**Project Description Update**

**Re: Wingfield Towers (LDC06-00321) – Preliminary Review Comment Response**

**City Planning Staff Comments and Wood Rodgers Responses**

**BSC MIXED USE DEVELOPMENT**  
**REVISED TENTATIVE MAP**  
**SITE PLAN - PARKING GARAGE LEVEL 1**

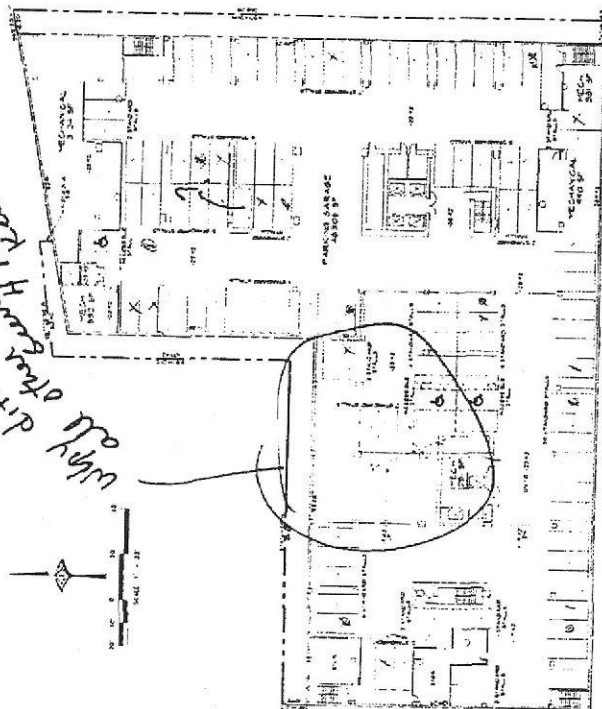
*Why different than other parking lots? More parking spaces for same footprint*

# BSC MIXED USE DEVELOPMENT REVISED TENTATIVE MAP SITE PLAN - PARKING GARAGE LEVEL 1

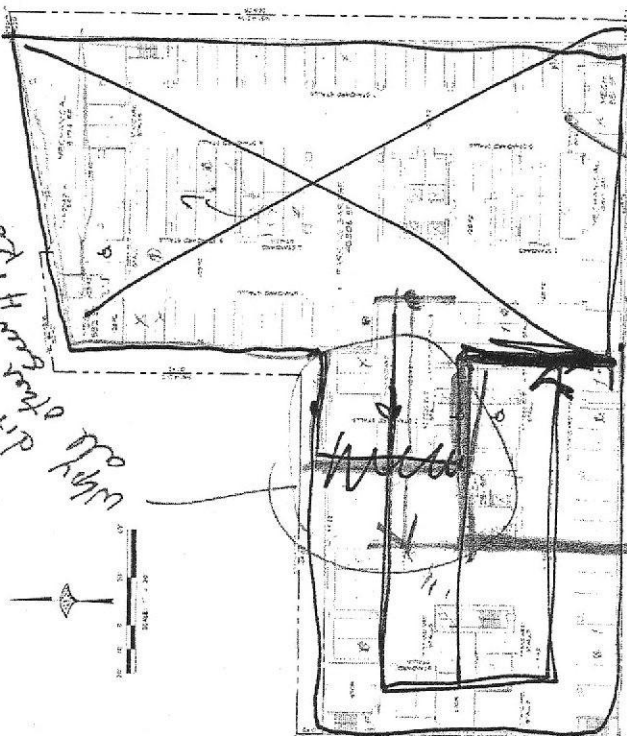
Why different than  
all other garages use  
could pick up  
new parking spaces by  
keeping same pattern
